DESIGN REVIEW BOARD/SIGN BOARD OF APPEALS REGULAR MEETING
THURSDAY, JUNE 20, 2019 - 7:00 p.m.
WINNETKA VILLAGE HALL COUNCIL CHAMBERS – 510 GREEN BAY ROAD

AGENDA

**Winnetka Design Review Board/Sign Board of Appeals
May 16, 2019**

TO: DESIGN REVIEW BOARD
FROM: CHRISTOPHER MARX, AICP, ASSOCIATE PLANNER
DATE: JUNE 14, 2019
SUBJECT: CASE NO. 19-19-DR: 555 CHESTNUT STREET (BUNNY AND BABE) -
CONSIDERATION OF CERTIFICATE OF APPROPRIATENESS

3 PARTIAL EXTERIOR ELEVATION (PRELIMINARY: TO BE FINALIZED AT DESIGN REVIEW BOARD MEETING ON 6/20/19)
A2.0 Scale: 1/2" = 1'-0"

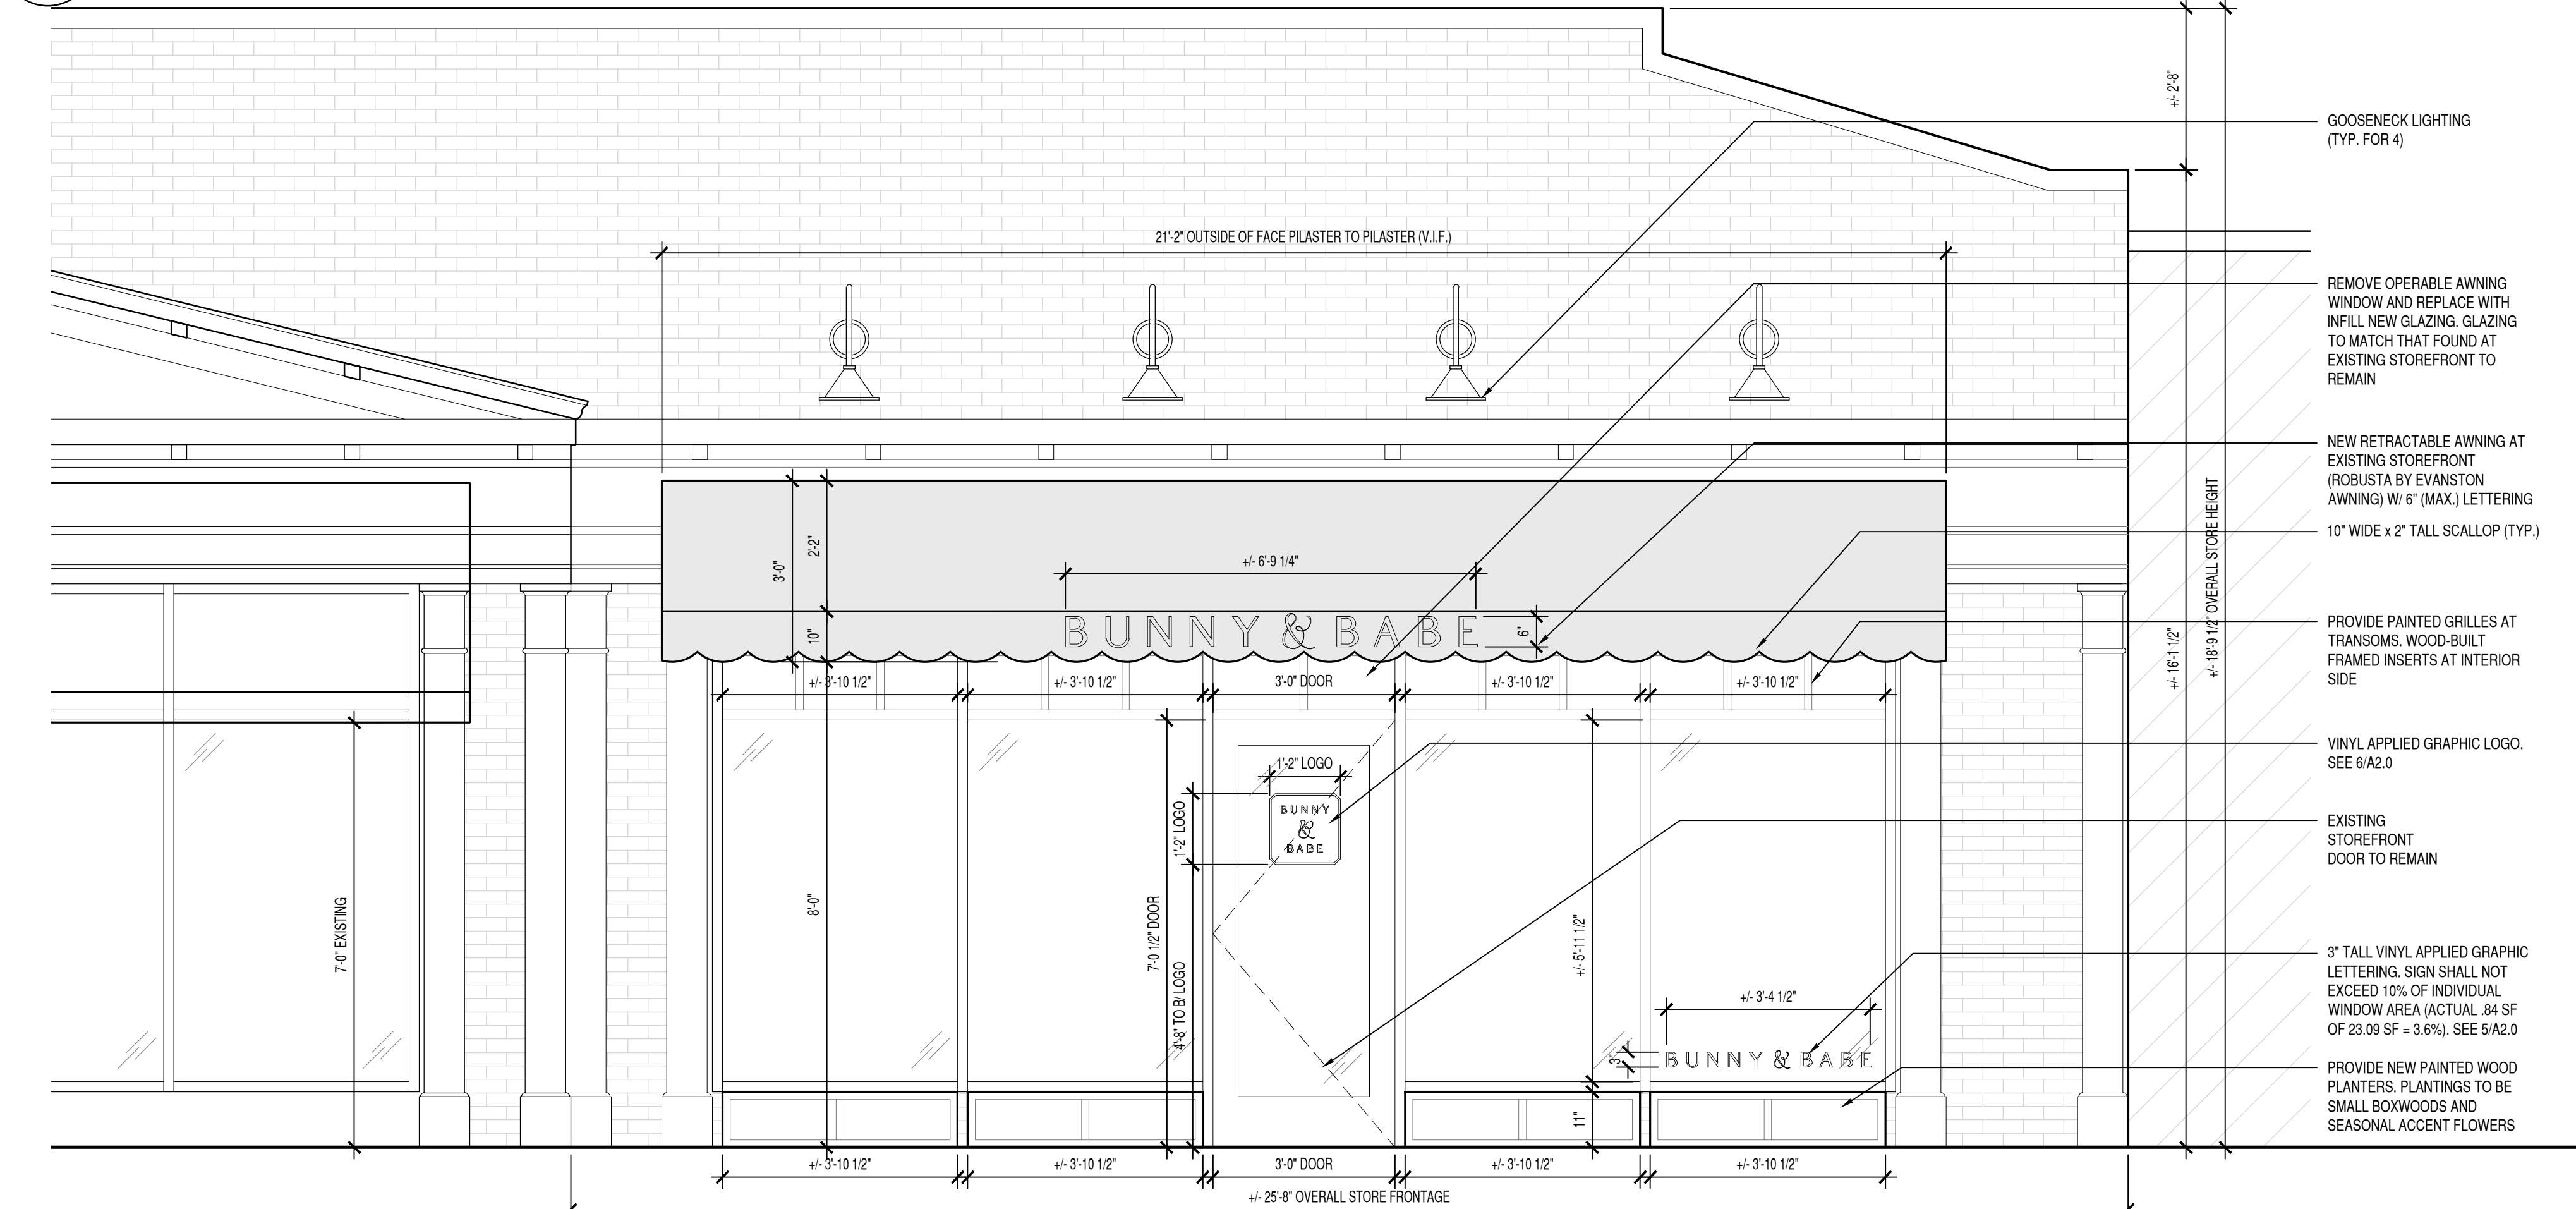
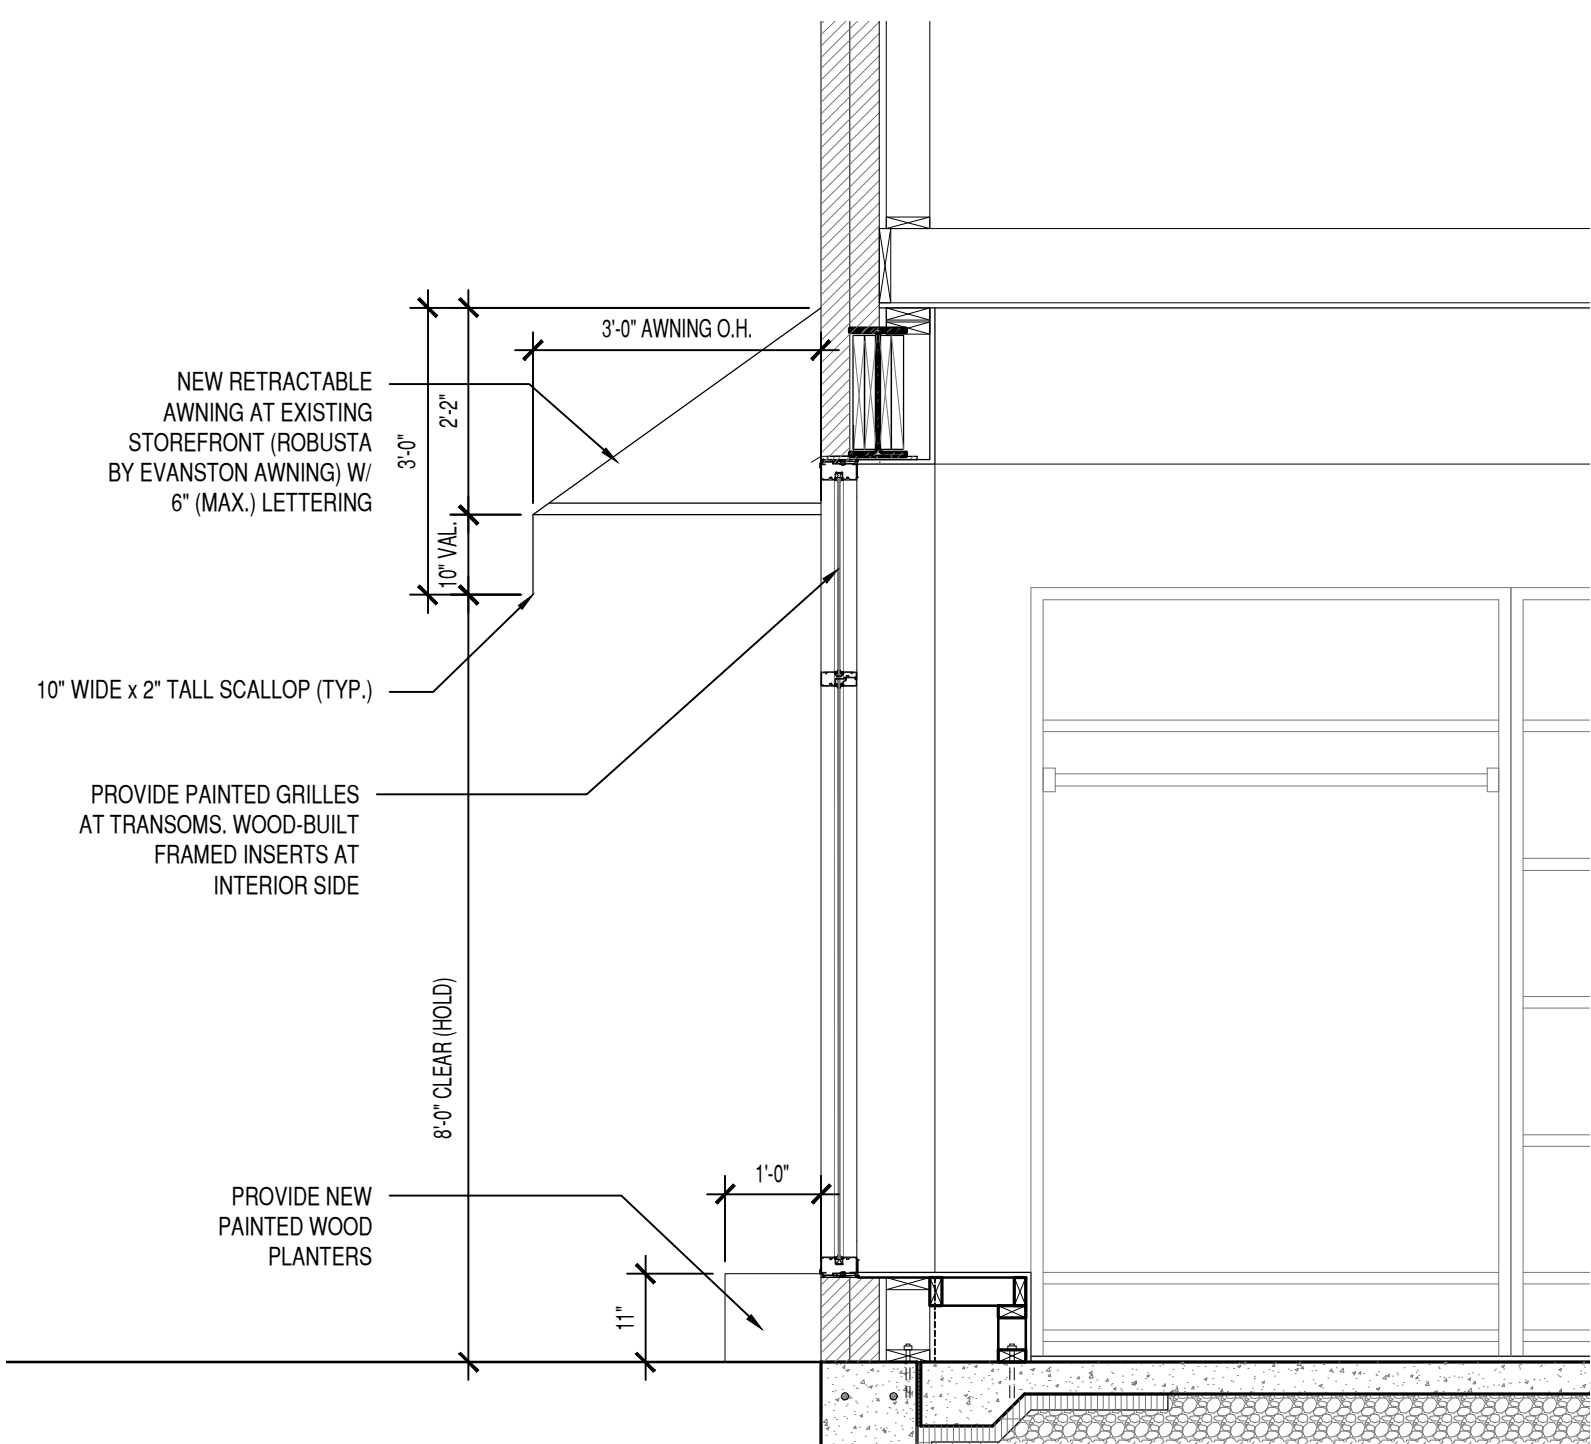
- Exterior lighting would be added at the top of the storefront on the sign band with the installation of four white metal gooseneck fixtures to provide downward illumination at the awning and signage.

- Wood planters would be installed at the base of the storefront. The planters would be painted in the same shade of blue as the awning while being 11 inches in height and 12 inches in width. They would be set out seasonally and contain small boxwoods and seasonal accent flowers.

- The Guidelines state that original storefronts with transom windows should be repaired and renovated when possible. The proposed exterior changes would enhance and preserve the existing transom windows. The Applicant is proposing to add painted wood grilles at the transoms on the interior side.
